HISTORIC DISTRICT COMMISSION ADDITIONAL INFORMATION REQUEST

Application Number: HDC2025-00065

NAME: john nova		COMPANY NAME: Nova Custom Homes LLC					
ADDRESS: 4155 hickory hills	CITY: dryden		STATE: MI	ZIP: 48428			
PROJECT ADDRESS: 4015 glendale st

HISTORIC DISTRICT: Russell Woods-Sullivan

Job No	Э.	25-024			
A-1					
Sheet	1	of	2

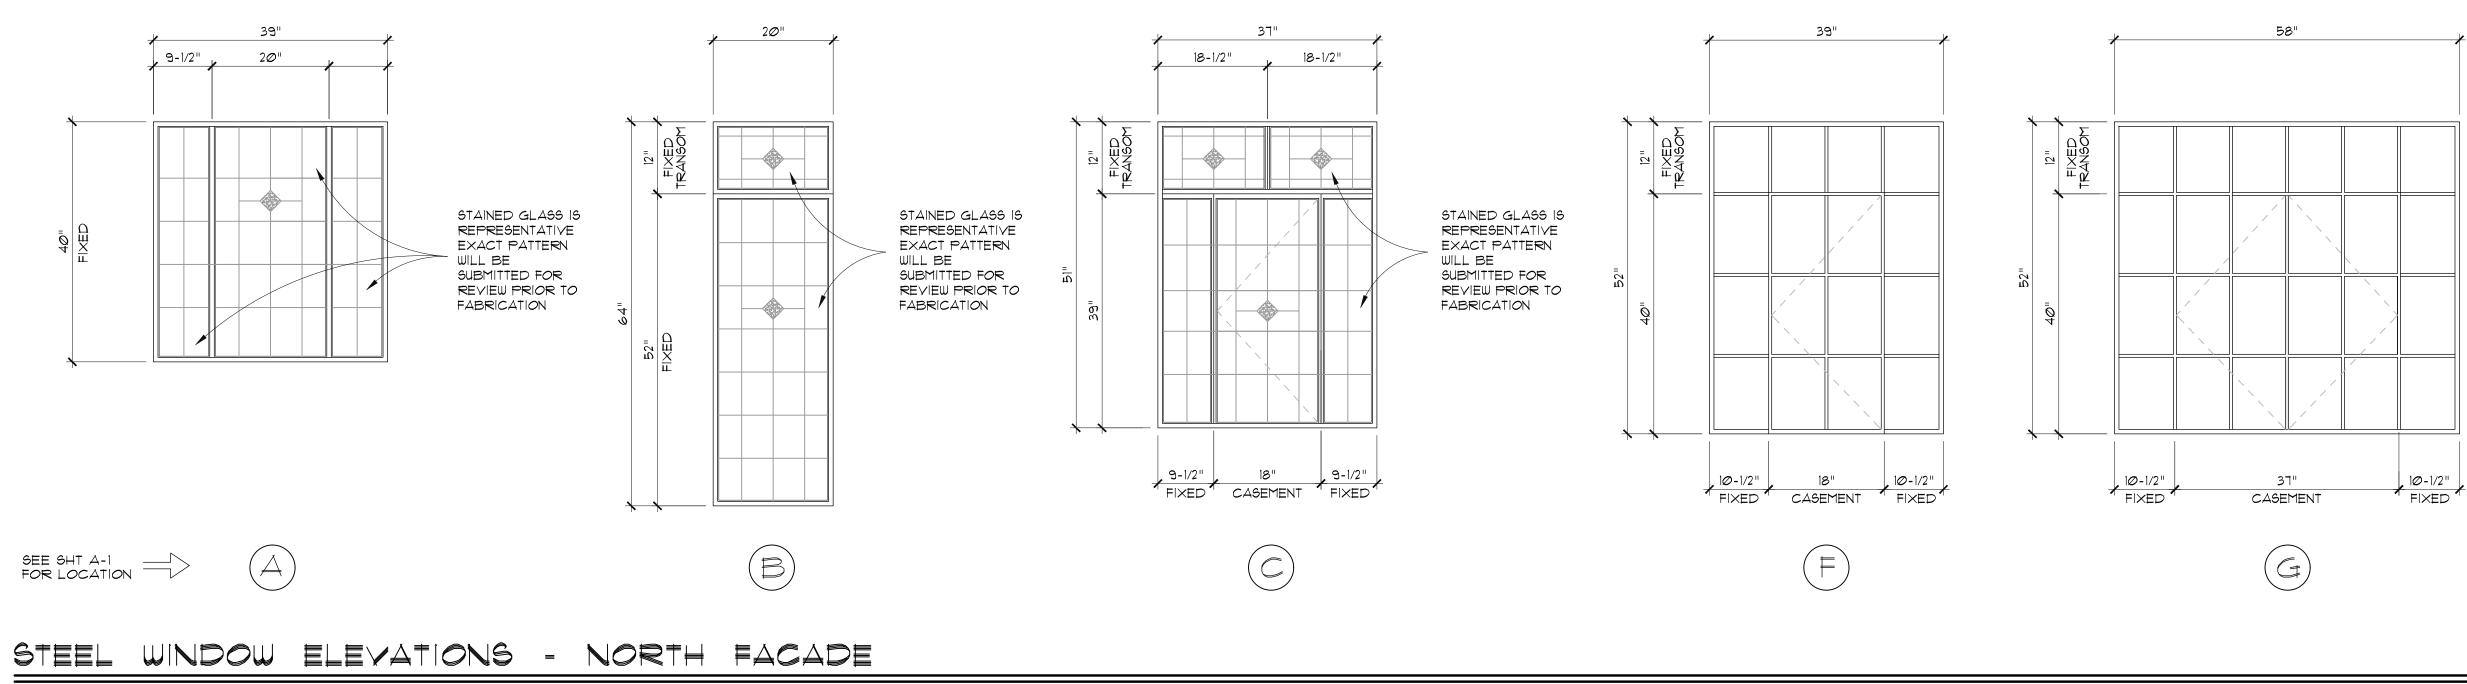
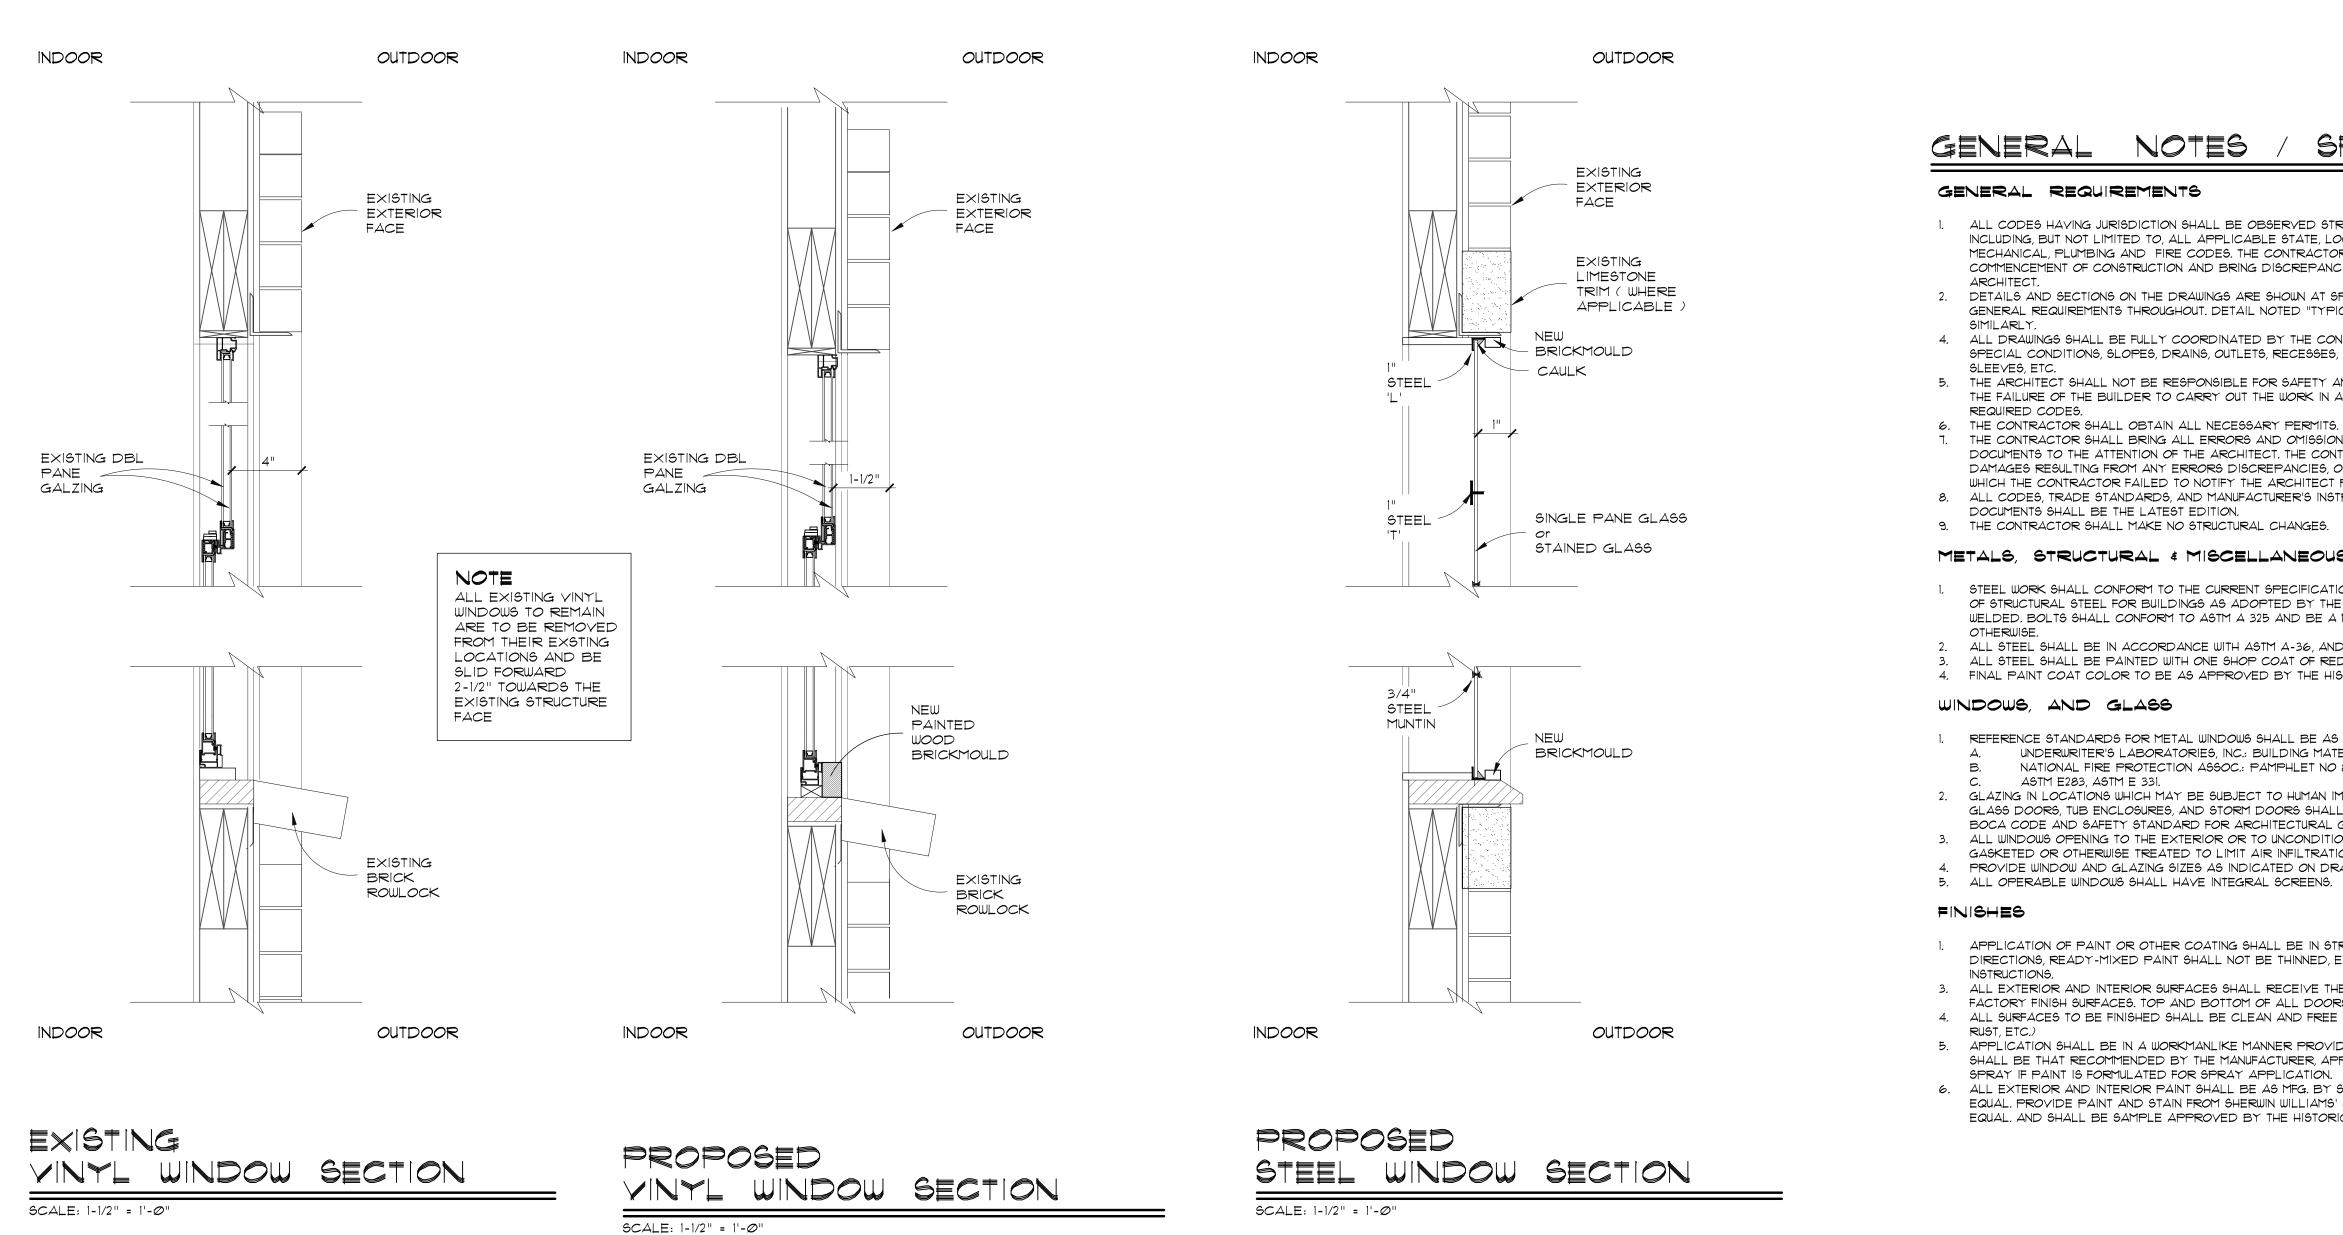
For the new steel windows at the front facade -

• a more detailed window schedule, which can be achieved:

The generation of a dimensioned elevation drawing of the front facade which shows the new windows, calling out their material, operation, and light configuration -OR- you can present window schedule/the information for each window opening at the front facade in a line-item format (which includes a sketch and specs per line/opening/window) as depicted in my attached document • dimensioned section drawings (vertical and horizontal) of the windows within the wall which show the typical profiles and dimensions at the muntins, meeting rails, sash, frames, and moldings. Since you indicate that these windows will be custom

This is the window schedule drawings as requested.
